Weiss Estates Water System
57259 Dodger Road
Bandon, OR 97411

Re: Water Treatment Plant Improvements (PR #2024-135)
Weiss Estates Water System – PWS # 05581

Thank you for your submittal to the Drinking Water Services (DWS) of plans for the new equipment at the water treatment at Weiss Estates Water System. Our office has received plans and a review fee of \$825.

Operating Diagram - Viqua Pro24-186

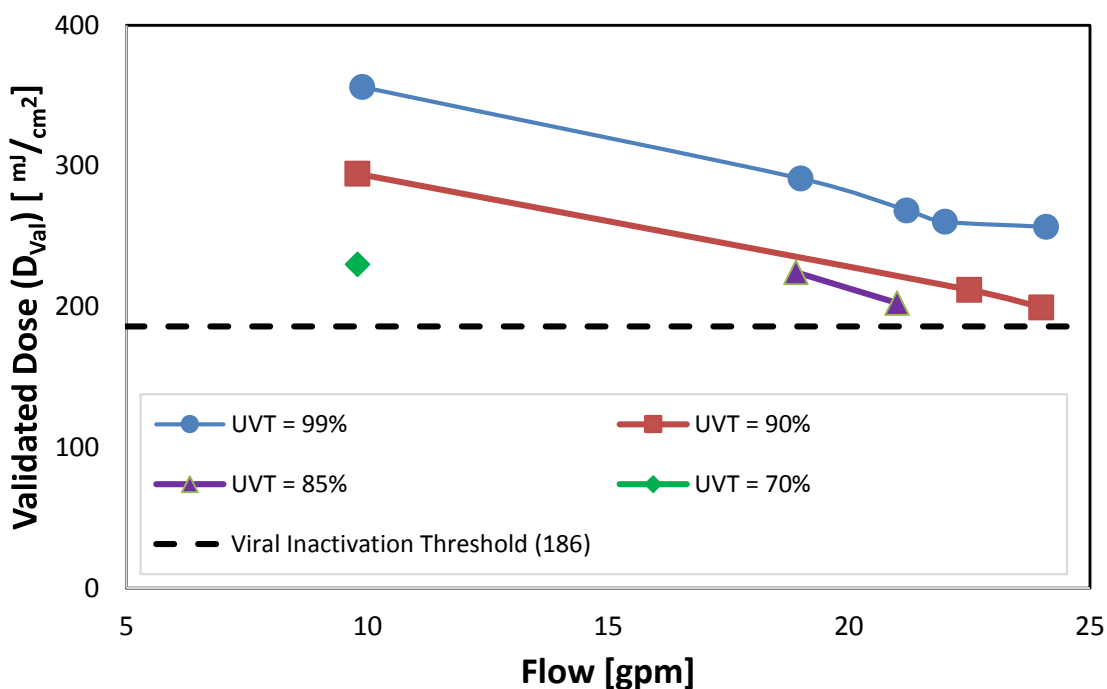
- The UV reactor was validated using the setpoint dose at a UV Transmittance (UVT) of 90% to 99%. Take UVT samples now to assure the UV reactor will be valid for your water system. (More about UVT below.)
- Attached are two graphs, one titled Operating Diagram – Viqua Pro24-186 and one titled Dose Curves that together depict the “Operating Range” for which this UV system was validated and is provided for its proper use. Use these to track volumes of off-specification (off-spec) water. For instance, at 20 gpm, the intensity must be at least 15 mA and the UVT must exceed 90% to achieve

appropriate pathogen inactivation; otherwise the water produced is considered off-spec. No water produced is allowed to be off-spec. This includes during warm-up mode.

- According to the UV validation report, the Viqua Pro24-186 has been granted the following inactivation credit by OHA-DWS as long as the UV reactor is operated within the operation diagram's boundaries:
